Groundwater Transfer Review Summary Form

Transfer/PA # T- 14792

Application: T-14792

Applicant Name: Cook Landholdings, LLC

T-14792 Cook Landholdings, LLC.

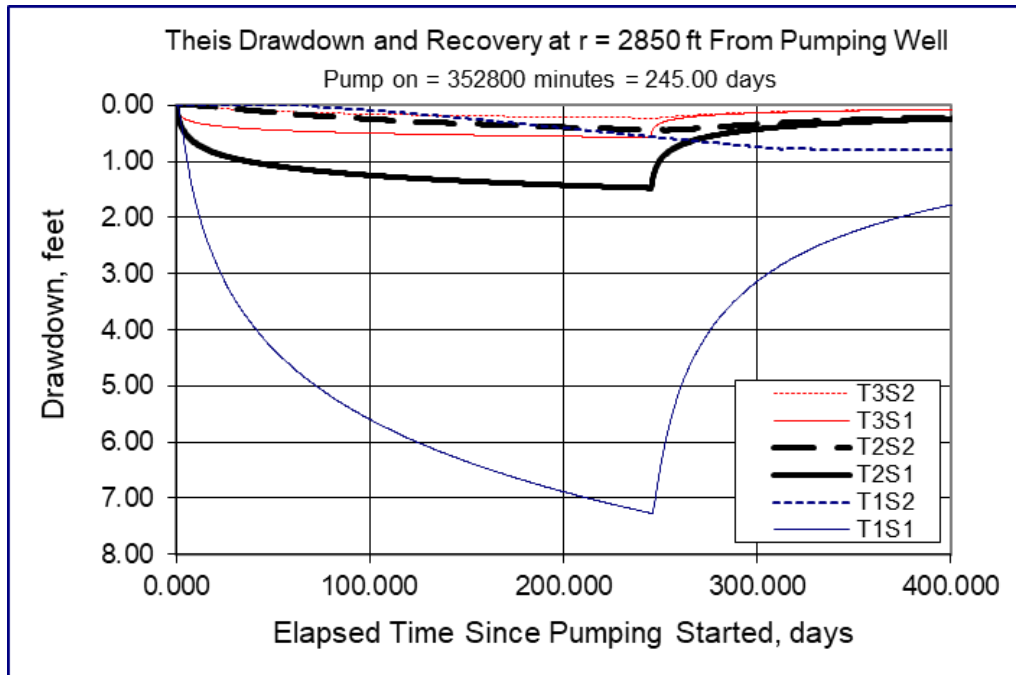
1. Basic description of the changes proposed in this transfer: Applicant proposes to add APOA Well 3 (NLOG 58045) to Claim GR-816. GR-816 authorizes POA 1/Well 2 (NLOG 58046) to irrigate 27.3 ac at 400 gpm and 68.25 AF/year. The APOA Well 3 (NLOG 58045) is also authorized under Claim GR-817 and is a proposed APOA on two other transfers currently under review. The combined rates are shown in the table below; the total rate and duty were used in this review.

2. Will the proposed POA develop the same aquifer (source) as the existing authorized POA?
 Yes No Comments: The authorized POA, Well 2 (NLOG 58046), and the proposed APOA, Well 3 (NLOG 58045), develop the unconfined Holocene alluvium.

5. a) Will this proposed change, at its maximum allowed rate of use, likely result in an increase in interference with **another ground water right**?
 Yes No Comments: The APOA, Well 3 (NLOG 58045), is closer to LINN 5302, a POA authorized for irrigation per Claim GR-712 with priority date 2/28/1947. The reduced intervening distance is likely to result in an increase in interference with LINN 5302.

Stream Depletion Analysis: Well 3 (NLOG 58045)-McCarthy Slough

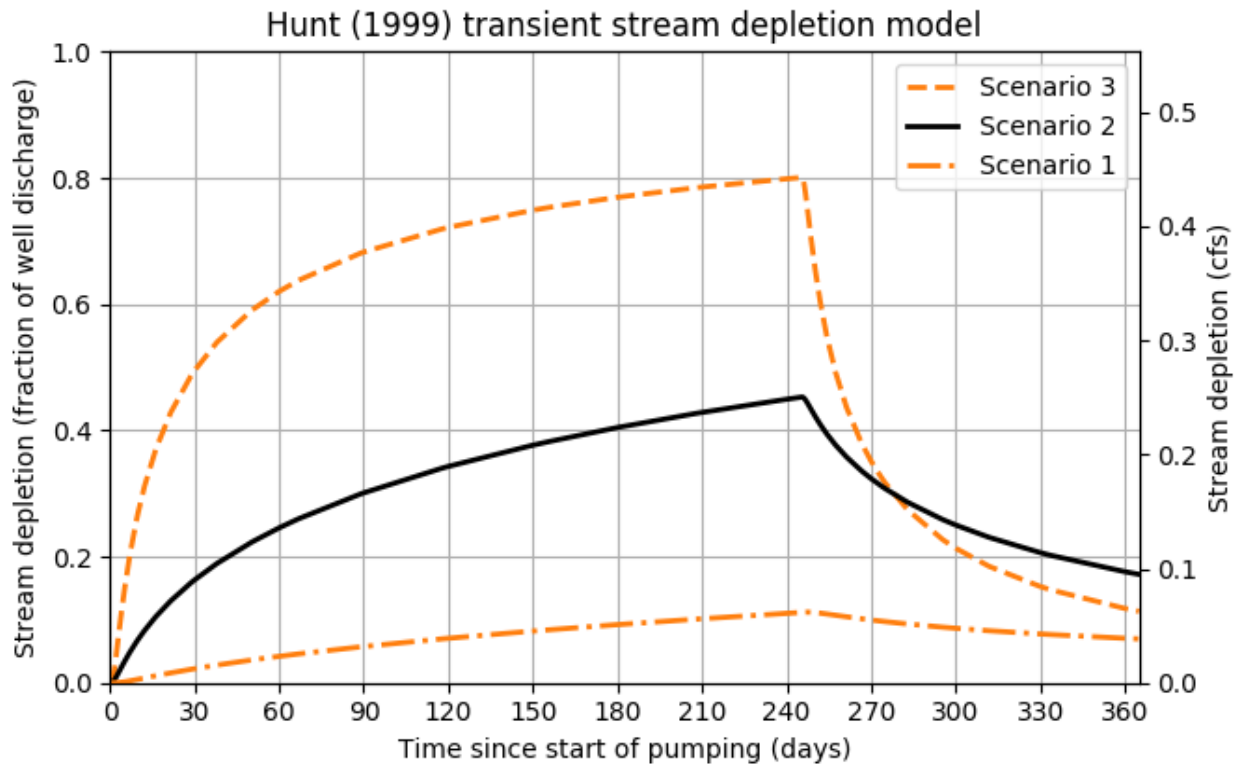
Yes No Comments: The APOA, Well 3 (NLOG 58045), is closer to SW 1 (McCarthy Slough). The reduced intervening distance is likely to result in an increase in interference with SW 1 (McCarthy Slough).

Provide context for minimal/significant impact: The expected increase in depletion from McCarthy Slough was assessed using the Hunt (1999) analytical model for stream depletion due to pumping in an unconfined aquifer (see attached Stream Depletion Analysis). Results indicate that stream depletion due to pumping could likely increase by 3% of the rate of withdrawal after 245 days of continuous pumping as a result of the proposed change. Assuming that the APOA, Well 3 (NLOG 58045), was to pump at the maximum rate of 0.553 cfs (248 gpm)* over the full 245 days, the proposed change could result in an additional 0.129 cfs (57.9 gpm) of depletions to McCarthy Slough by the end of the irrigation season. McCarthy Slough is within WAB #183 with the lowest month of natural stream flow in August; the Net Water Available in August is 990 cfs. The change in degree of interference with McCarthy Slough by the APOA, Well 3 (NLOG 58045) is anticipated to be minimal.
